Morbark Ford 6.2 Engine Post Production Modification (PPM-103)

Publish Date:	03/29/2022
Last Revised:	--
Created by:	AB
Total Pages:	10
PPM#	103

Overview

Figure 3

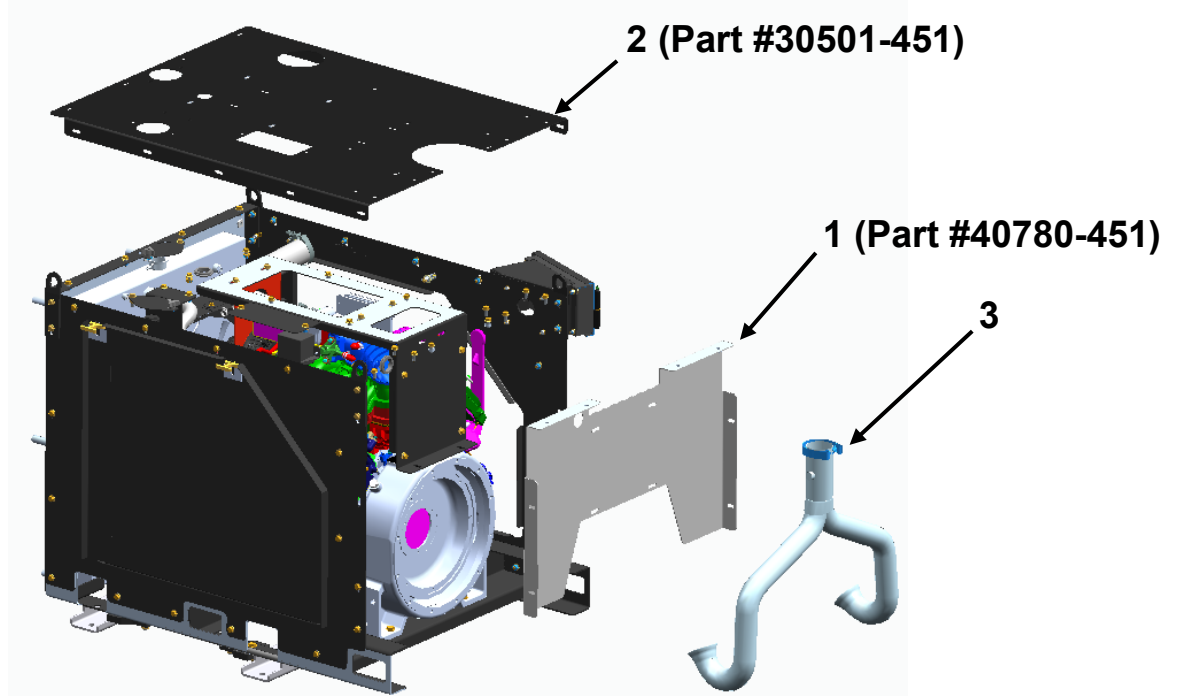
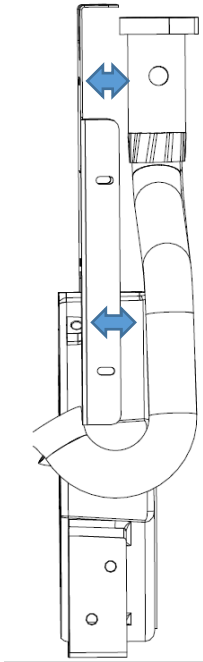
- When changing the fans, adjust the exhaust Y-pipe so it is straight up and down. We initially had these clamped to the firewall but this allowed too much heat to pass through the firewall.
- Loosen the exhaust manifold joints and pull the pipe back away from the fire wall and re-torque.
- The Catalyst assembly can be adjusted forward and back to allow better fitment of the 90 degree exhaust elbow. Here are some pictures of what it should look like.
- Also remind anyone running a Ford 6.2 liter to only use **5w-30 motor oil**. Using a thicker oil with a higher winter weight (10w, 15w) in the winter may cause timing chain damage.
- Double check that all wiring harnesses are tied back away from any heat sources like the exhaust manifolds.

NOTE: Do NOT reuse U bolt clamps when re-installing Y-pipe.

Make sure pipe is aligned so that there is even clearance between pipe and chimney weldment as

Use 3" band clamp. Make sure elbow is fully seated and there are no leaks at slots.

Figure 5

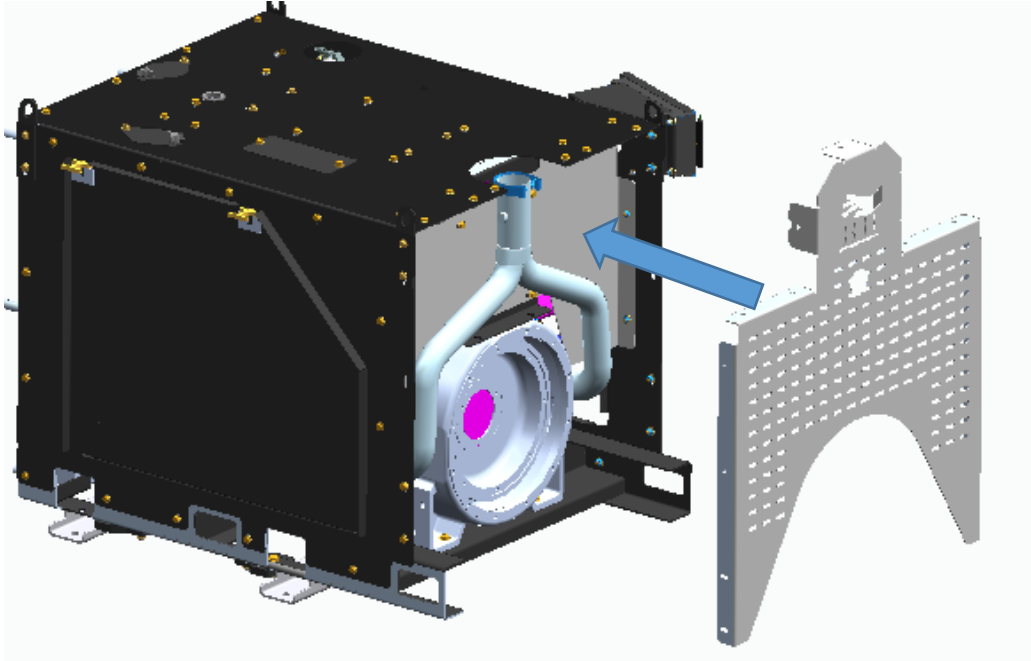
4) See Figure 5. Install Rear Panel using existing hardware.

Figure 6

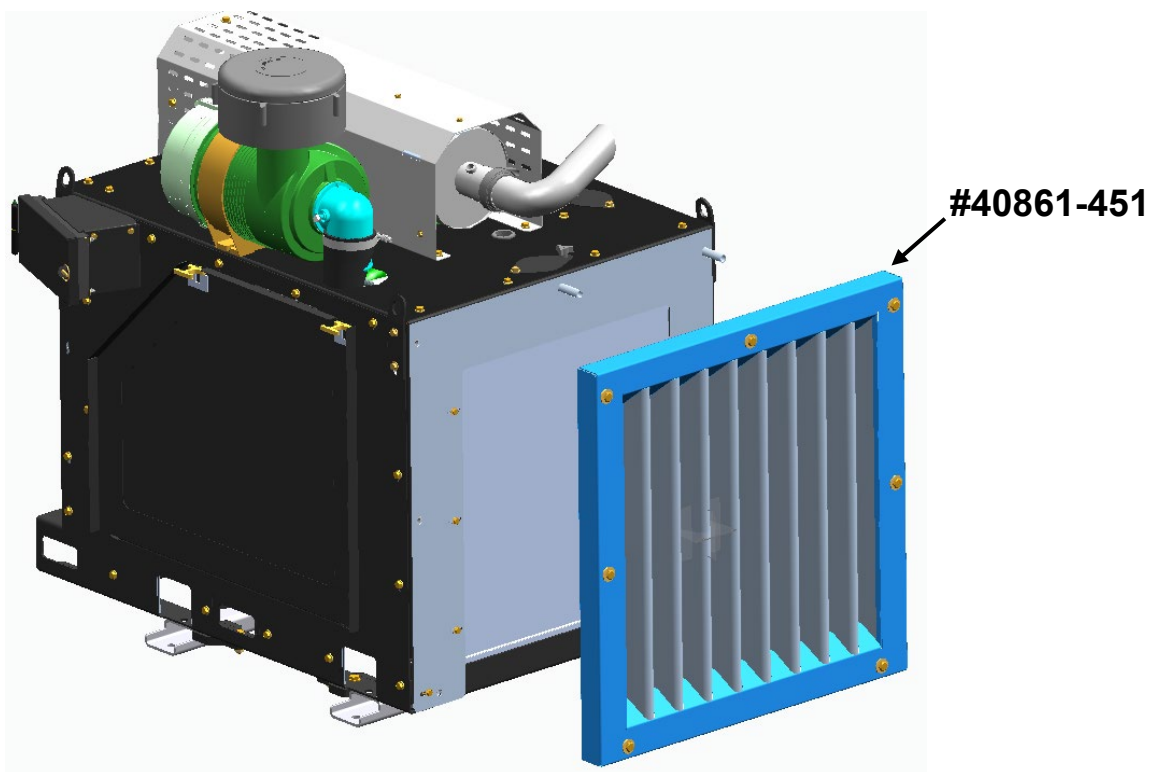
5) See Figure 6. Install Muffler Assembly, Radiator Cover, Access Panel, and Engine Air Intake Assembly using existing hardware then install replacement debris screen as shown.

Figure 7

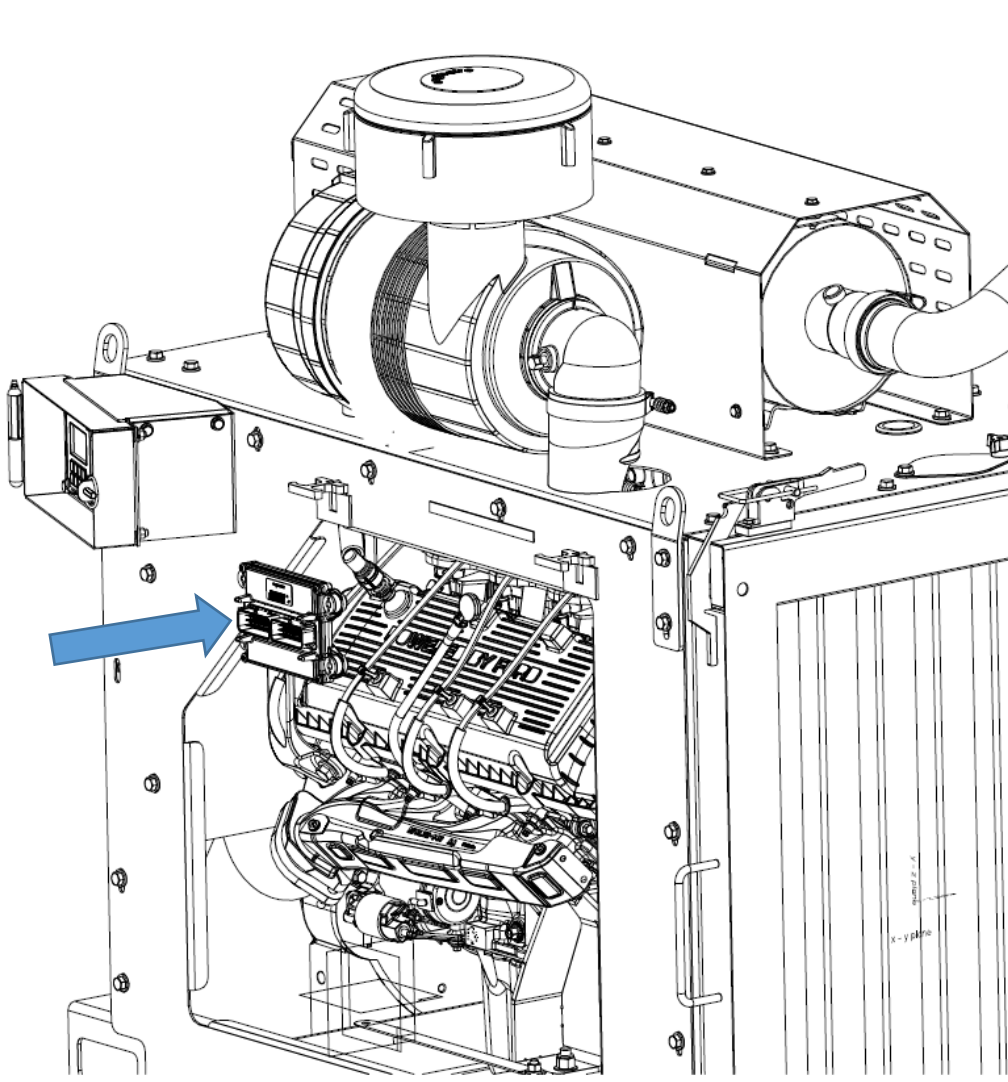
Update or Replace ECM

To update existing ECM contact Art Wicks EDI Service Manager (art@edi-dist.com) to update existing ECM.

- Calibration: 5380R35D_GAS_TSC1_1200-3200

- 1) See Figure 7. Remove screws.
- 2) Disconnect wire harnesses.
- 3) Remove ECM.
- 4) Install new one in reverse.
